**Cambrian Quarry,  
Gwernymynydd,  
Mold**

Interpretative Report

## Section 7.4 INFILLING OPERATIONS-STABILITY

**Revision: Revised 06/12/2012 by Keith Nicolls, Geotechnics Ltd**

Title: PROPOSED RESTORATION PLAN	Scale: 1:500	Grid Ref:
Drawing No: 2304/426/01	Date: 28 November 2012	Revision: A
Site: Cambrian Quarry, Gwernymynydd, North Wales	Drawn by: RS	Checked: <input type="checkbox"/>
Client: Alan's Skip Hire Ltd	Client No: 426	Job No: 2304
		Printed at: A1

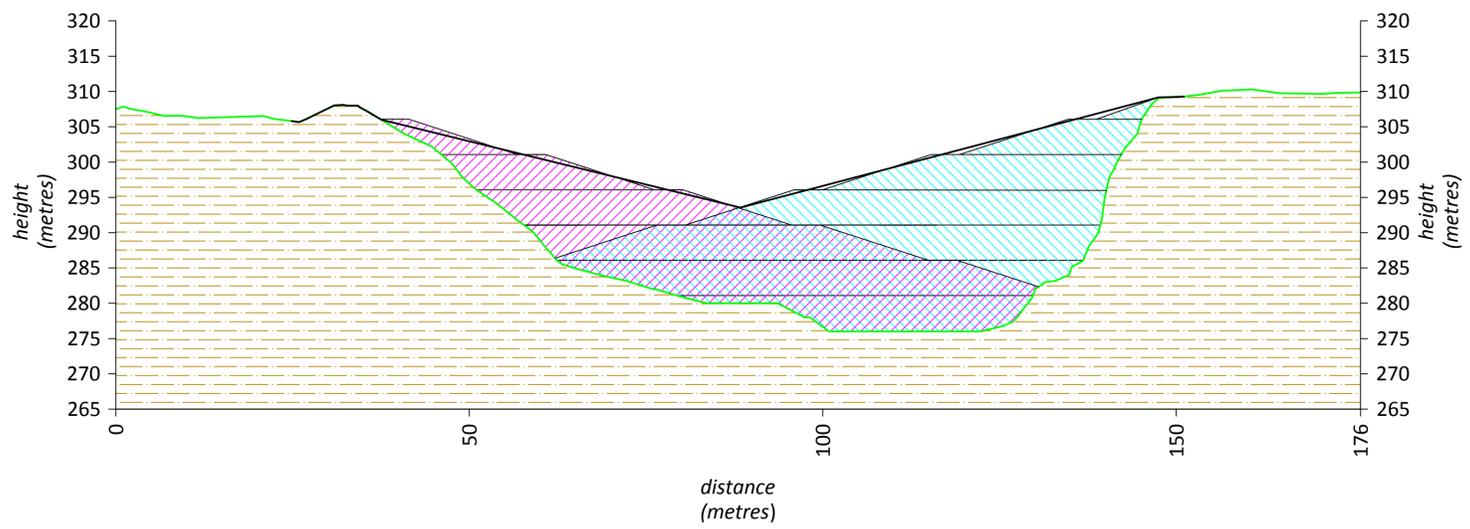
Rev	Description	Date
-	Draft for consultation	14/08/12
A	Updated draft - restored slopes amended to between 1 in 3 and 1 in 4 as per EA agreement	28/11/12

- bench heights should not exceed 5m,
- berm widths should not be less than 3m, and
- the local slope angle (between toe of slope and crest of bench) should be no greater than 23°.

Title: CROSS SECTIONS	Scale: 1:500	Grid Ref:
Drawing No: 2304/426/02	Date: 5 December 2012	Revision: B
Site: Cambrian Quarry, Gwernymynydd, North Wales	Drawn by: RS	Checked: RD
Client: Alan's Skip Hire Ltd	Client No: 426	Job No: 2304
		Printed as: A1

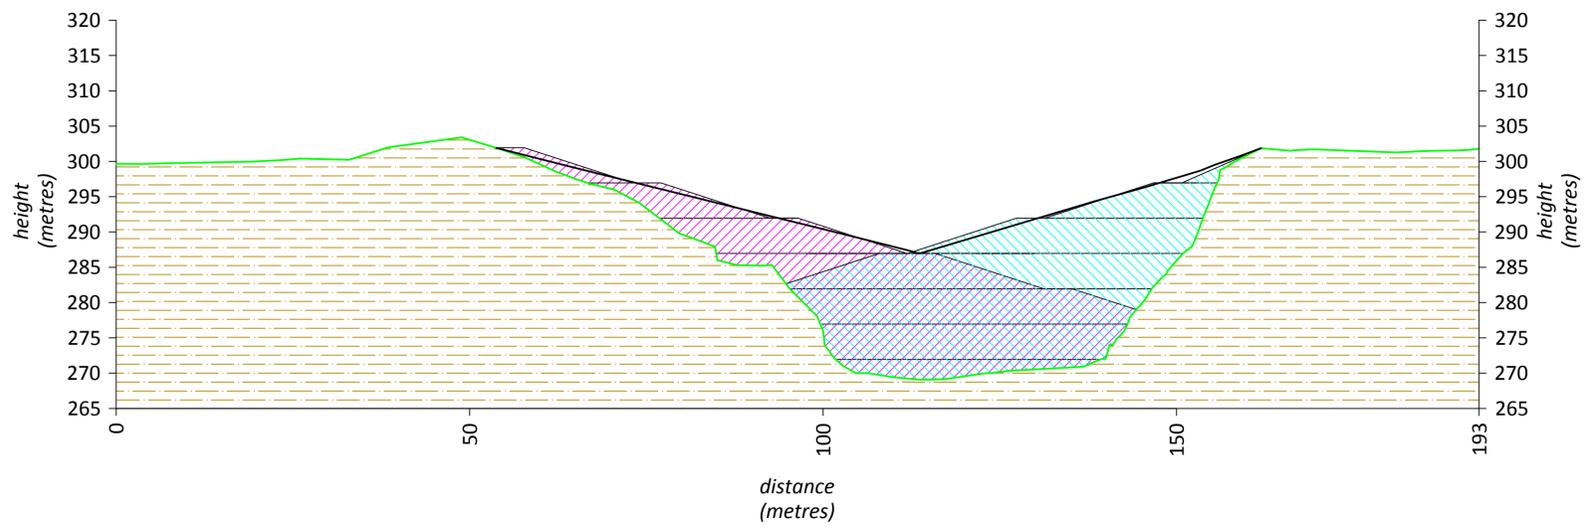
Revision Details:		
Rev	Description	Date
-	Draft for consultation	14/08/12
A	Updated draft - restored slopes amended to between 1 in 3 and 1 in 4 as per EA agreement	28/11/12
B	Section refs. wrong in Revision A - corrected	05/12/12
